Final Plans for Bidding and Construction

DENTON ISD

ELEMENTARY SCHOOL #23
PALOMA CREEK SOUTH SITE

LP 1.01

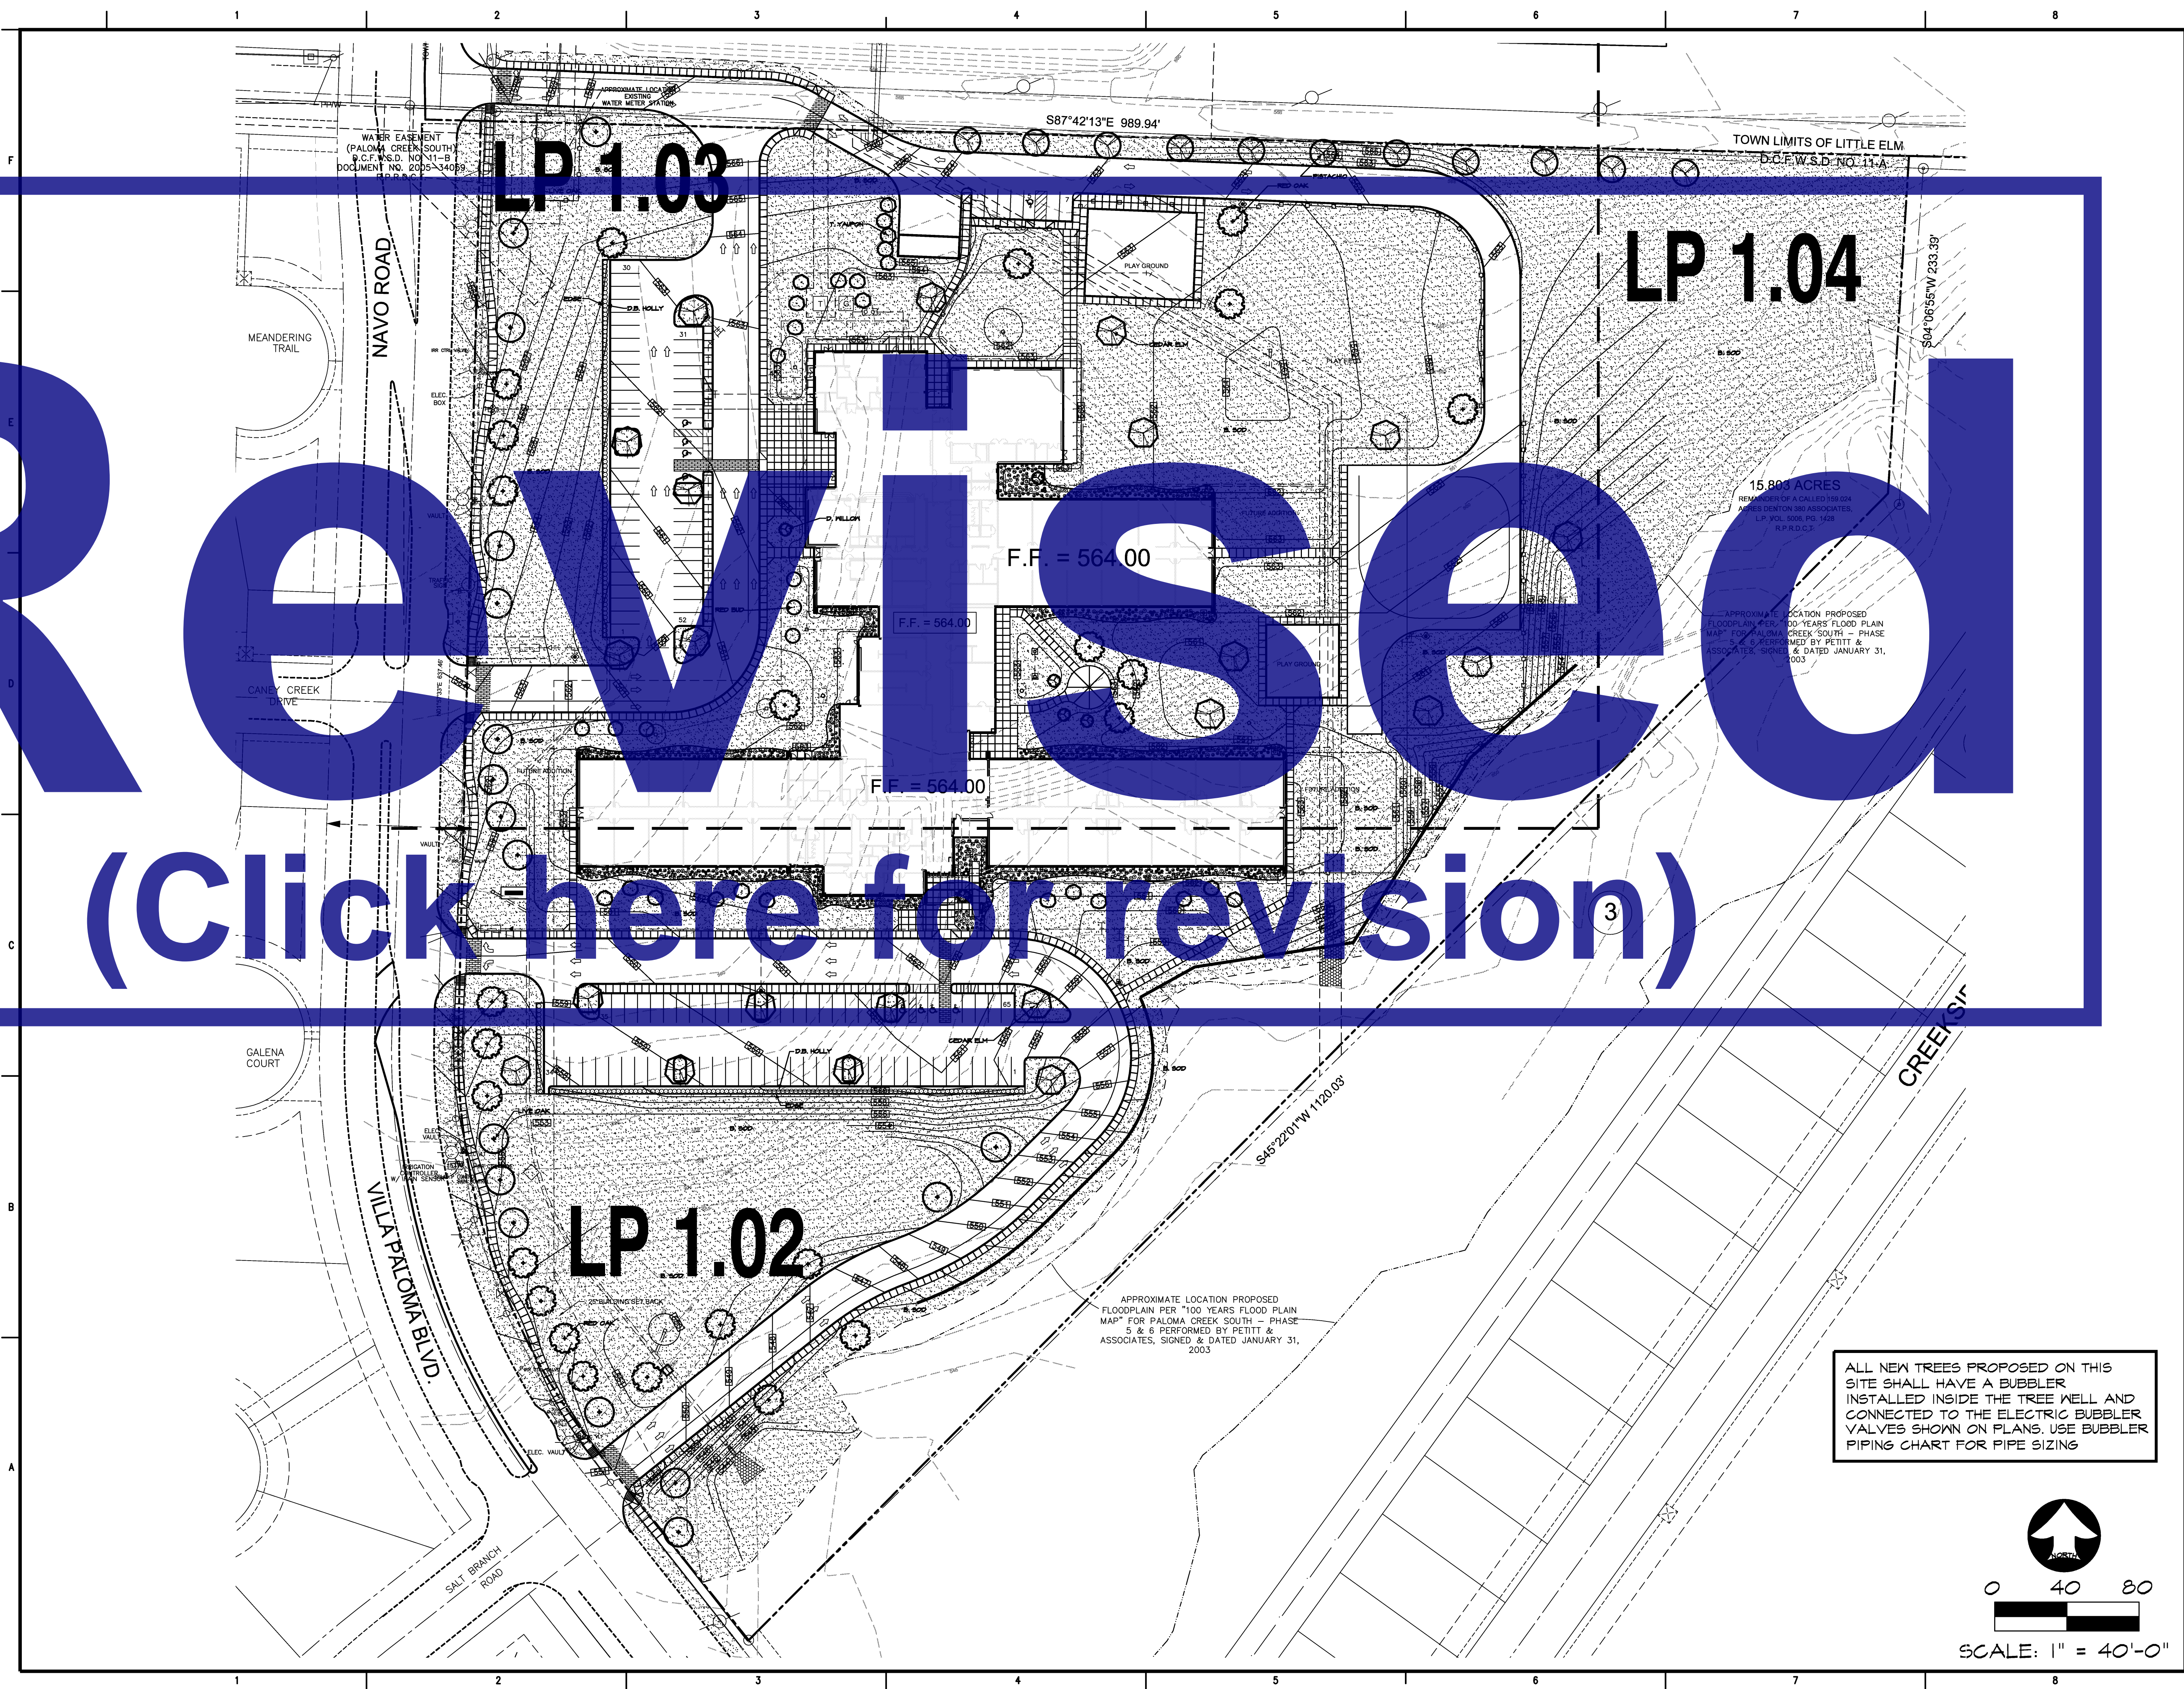
- 1. Sheet **LP101** – Overall Landscape Plan: Replace sheet in its entirety
 - a. Add trees and shift other trees along the entire street frontage.
- 2. Sheet **LP102** – Landscape Plan Area A: Replace sheet in its entirety
 - a. Add trees and shift other trees along the entire street frontage.
- 3. Sheet **LP103** – Landscape Plan Area B: Replace sheet in its entirety
 - a. Add trees and shift other trees along the entire street frontage.
- 4. Sheet **LP105** – Landscape Enlargement: Replace sheet in its entirety
 - a. Add trees and shift other trees along the entire street frontage.
- 5. Sheet **LP501** – Landscape Details: Replace sheet in its entirety
 - a. Tree count in plant legend updated for the trees added along the street frontage.
